HISTORIC AND DESIGN REVIEW COMMISSION

August 18, 2021

HDRC CASE NO: 2021-370
ADDRESS: 1017 S ALAMO ST
LEGAL DESCRIPTION: NCB 744 BLK 3 LOT 5
ZONING: NC S, H
CITY COUNCIL DIST.: 1
DISTRICT: King William Historic District
LANDMARK: Individual Landmark
APPLICANT: Bryce Johnson/Bravo Roofing
OWNER: RED BLUE PROPERTIES LLC
TYPE OF WORK: Installation of a standing seam metal roof featuring brown panels and a ridge cap
APPLICATION RECEIVED: July 21, 2021
60-DAY REVIEW: Not applicable due to City Council Emergency Orders
CASE MANAGER: Edward Hall

The applicant is requesting a Certificate of Appropriateness for approval to install a standing seam metal roof featuring a brown color and ridge caps.

<p>Photographs</p>	<p>June 23, 2021 at 11:51 AM 1901 S Alamo St San Antonio TX 78204 United States</p>
--------------------	---

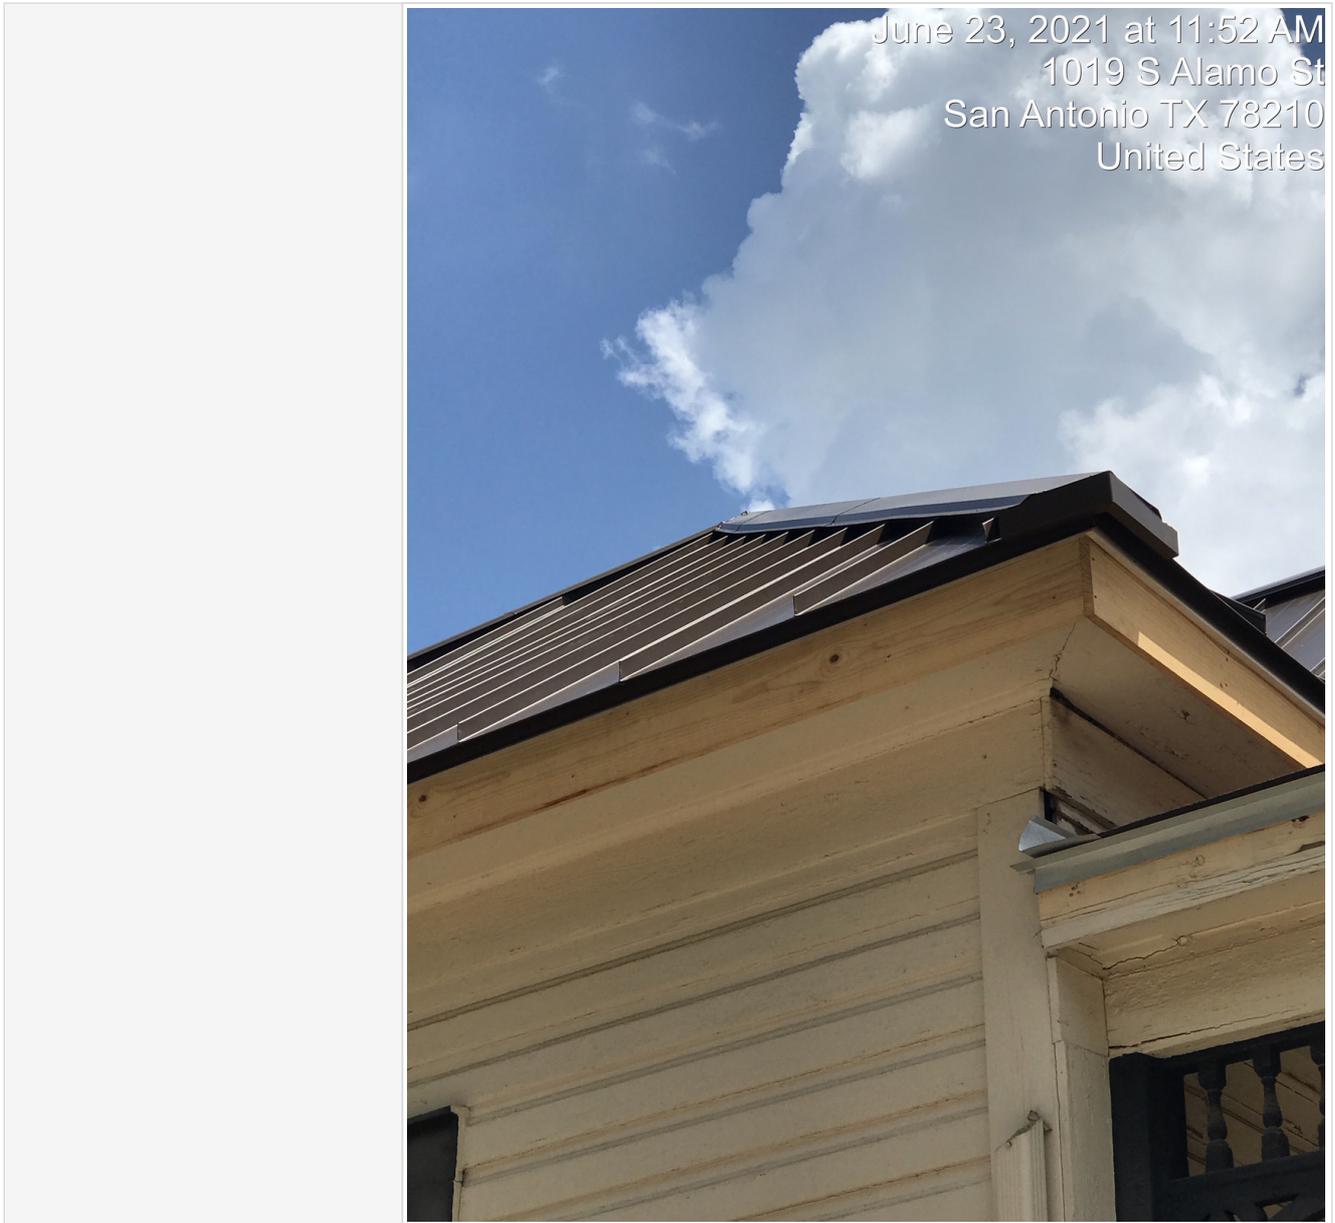
Date	06/23/2021
Time	11:57 AM (-5 GMT)
Context	citizen report
Present Staff	Edward Hall
Present Individuals	Other
Types of Work Observed	Exterior Maintenance and Alterations
Amount of Work Completed	Completed
Description of work	The installation of a brown standing seam metal roof with a large ridge cap and fascia and trim replacement.
Description of interaction	EH spoke with office staff. A Notice of Violation was issued.
